**WEST VIRGINIA DEPARTMENT OF ENVIRONMENTAL PROTECTION  
WV/NPDES CONSTRUCTION STORMWATER PERMIT**

<b>FACILITY NAME:</b>	Northport Avenue Extension			<b>REG. #</b>	<b>EXPIRE DATE:</b>
<b>PERMITTEE</b>	RANSON, CITY OF			WVR110191	9/2/2020
<b>ADDRESS/PHONE:</b>	Attn: ANDREW P. BLAKE, CITY MGR 312 SO MILDRED ST RANSON, WV 25438 3047251010				
<b>LOCATION:</b>	39 22 12.95 N77 52 32.83 W			<b>Entry Date/Time:</b>	2/6/2020 @ 1103
<b>COUNTY:</b>	Jefferson			<b>Exit Date/Time:</b>	2/6/2020 @ 1224
<b>Site Representative /Phone</b>				<b>PHOTOS</b> <input checked="" type="checkbox"/>	
<b>CO-PERMITTEE:</b>				<b>ADDRESS:</b>	
<b>SITE OPERATOR:</b>				<b>ADDRESS:</b>	
<b>PERMITTED ACREAGE</b>	24.4	<b>WEATHER:</b>	Rain	<b>LAST INSPECTION:</b>	N/A
<b>RECEIVING STREAM(S)</b>	Rockymarsh				<b>NOV:</b> <b>W20-19-012-TDH</b>
<b>Regular Mail</b> <input type="checkbox"/> <b>Certified Mail</b> <input checked="" type="checkbox"/>		<b>Tracking #</b> 70192970000166130895			
<b>OVERALL FACILITY RATING:</b>	<b>Unsatisfactory</b>		<b>COMPLIANCE OUTCOME</b>	<b>Not Immediately Corrected</b>

STATE OF WEST VIRGINIA  
Department of Environmental Protection  
Environmental Enforcement  
NOTICE OF VIOLATION

Viol

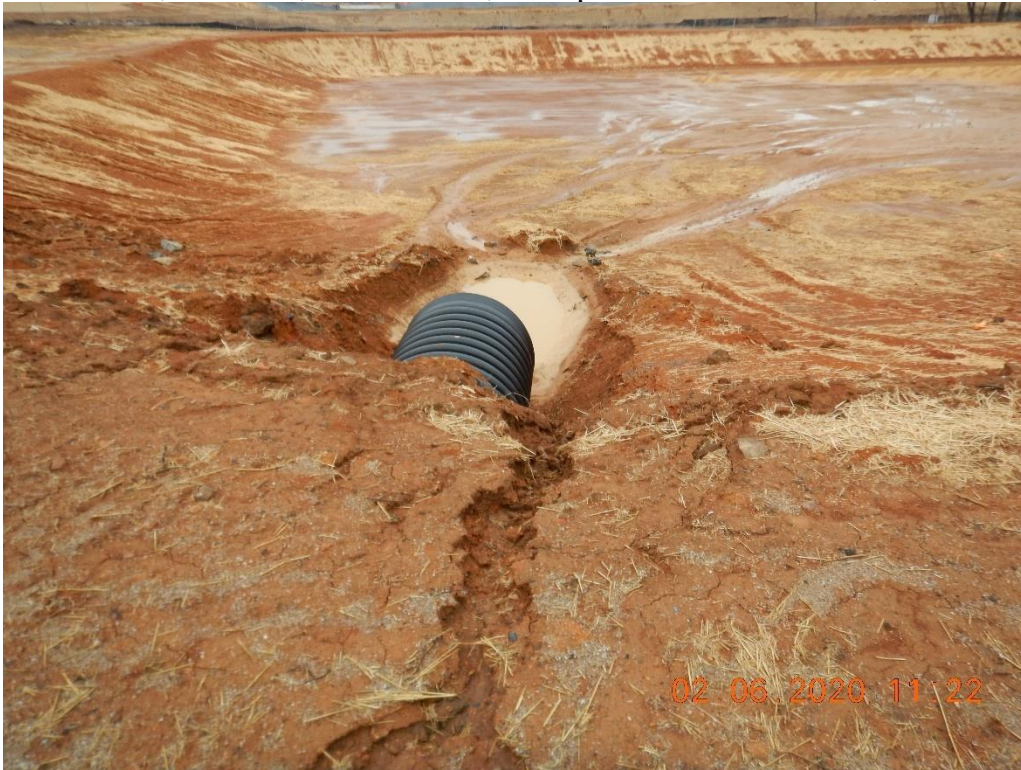
Perimeter controls are not properly installed, there are many areas where the toe of the silt fence was not toed in correctly and many panels of silt fence was not conjoined correctly as indicated in the plan details on sheet 19.

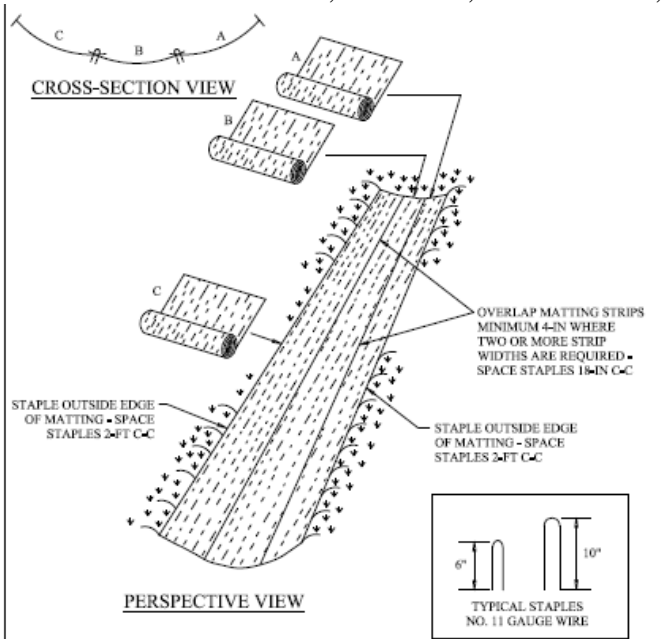
Diversion channel #1 from sediment basin outlet not installed.

Diversion channel #1 and rip rap apron #2 not installed at time of inspection.

**EROSION CONTROL MATTING DETAIL**  
NOT TO SCALE

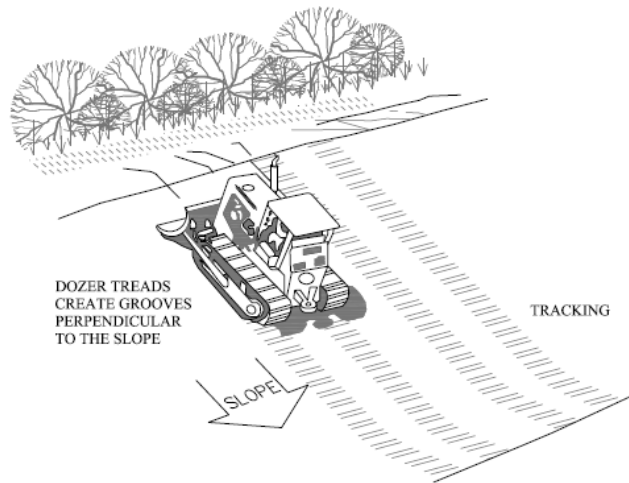
Diversion channel not installed per plan sheet details with ECM and rock check dams.

**TRACKING A CONSTRUCTED SLOPE**  
NOT TO SCALE

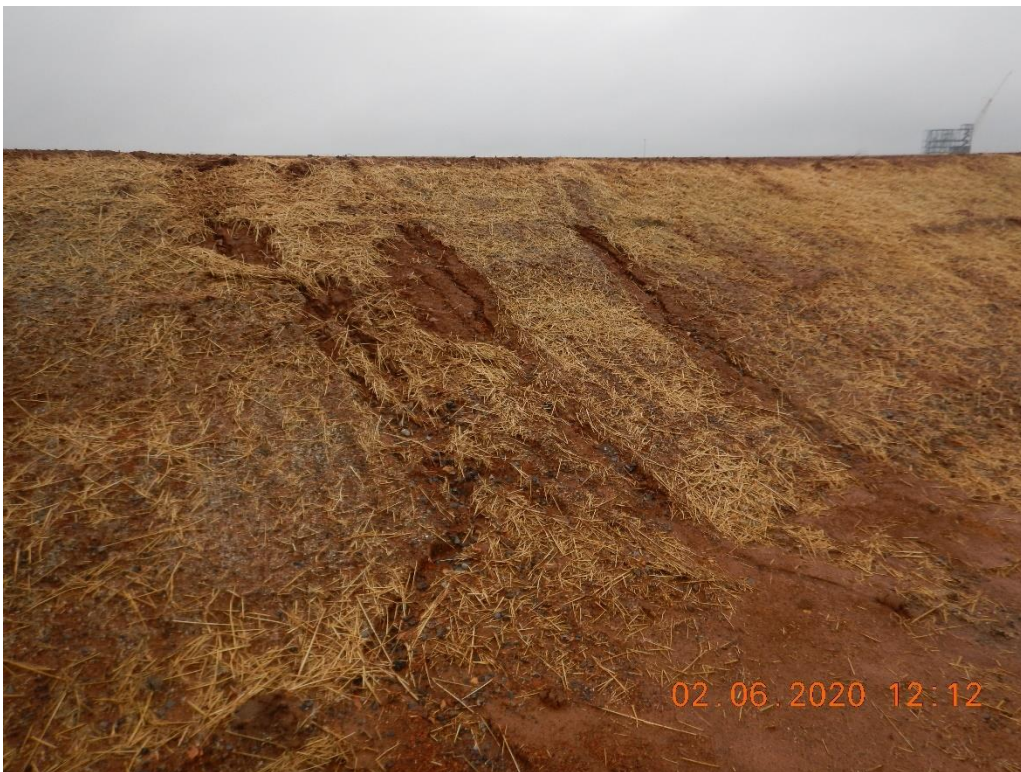
Improperly tracked in constructed slopes are aiding in the development of erosion rills to form on fill slopes that are found throughout the project site.
